The First Joint Meeting of the Asia/Pacific Aerodrome Design and Operations Task Force (AP-ADO/TF/1) and Asia/Pacific Aerodrome Assistance Working Group (AP-AA/WG/1)

Bangkok, Thailand, 25 to 27 September 2019

PROPOSALS FOR THE AMENDMENT OF ANNEX 14, VOLUME I AND CONSEQUENTIAL AMENDMENT TO PANS-AERODROMES (DOC 9981)

Current situation for NINST runways codes 1 and 2

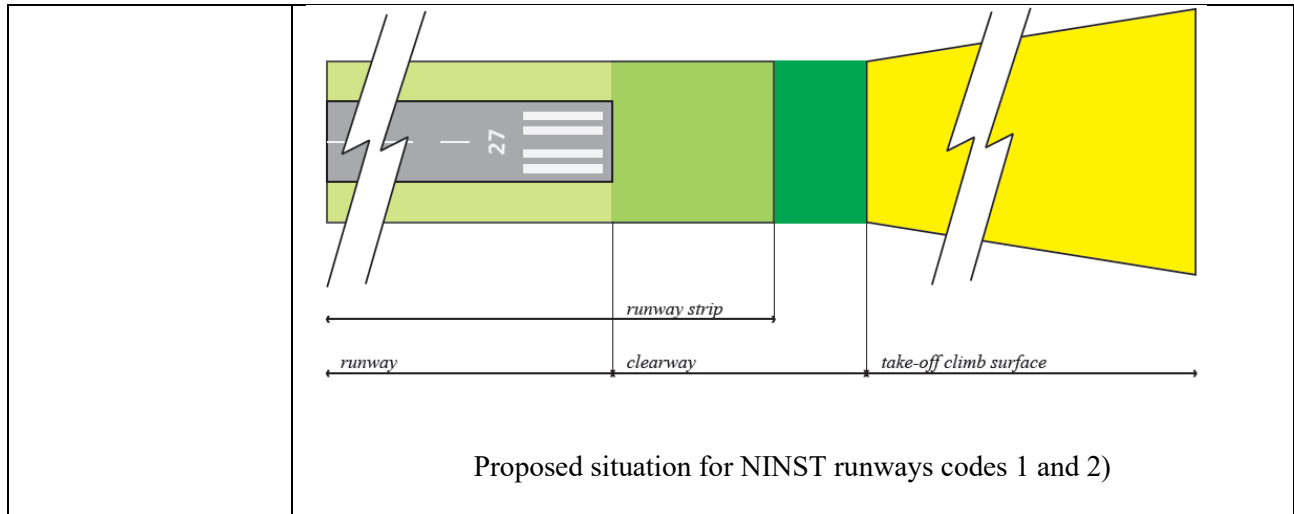
Annex 14, Vol. I currently specifies the width of a clearway regardless of the type and code number of the associated runway. Due to terrain or other restrictions, it may not always be possible to provide the full recommended 75 m half-width of a clearway on non-instrument runways where the code number is 1 or 2. For these types of runways, the existing recommended width of the clearway will therefore greatly exceed that of the associated runway strip (30 m and 40 m half-width, respectively) and provide a disproportionate lateral protection compared to the width of the associated runway strip as well as to the length of the inner edge of the obstacle limitation surface (OLS) according to Table 4-2, Annex 14 Vol I.

The proposed amendment is expected to result in a positive impact on safety since, as per current provisions, aircraft above the clearway area, along its outer boundaries, would not have the area available as established by the take-off surface specifications, to transition to a recognized climb profile as depicted in the figures. Furthermore, it aimed at providing a coherent approach for safety areas where obstacles are restricted. Due to the fact that the inner edge of the OLS was as wide as the width of the associated runway strip, there was no safety benefit in providing a wider clearway.

Several States (e.g. Australia, Canada, Italy and United Kingdom) have already taken account of these circumstances in different ways and have implemented national regulations which are different from ICAO.

Figure A4-4. Sign dimensions

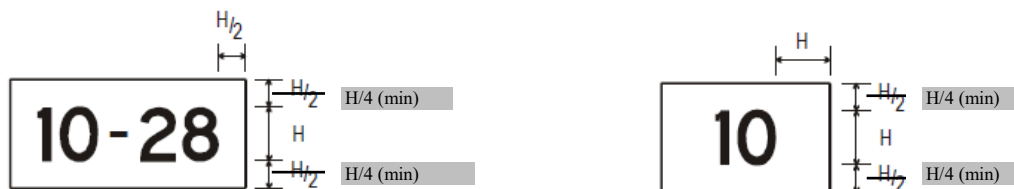
Origin: ADOP/3	Rationale: The changes in Appendix 4 stem from proposed changes to Chapter 5, Table 5-5. The explanatory Note is deemed necessary in order to define “H” as the inscription height for clarification reasons as it has not been stated before in ICAO documents.
------------------------------	--
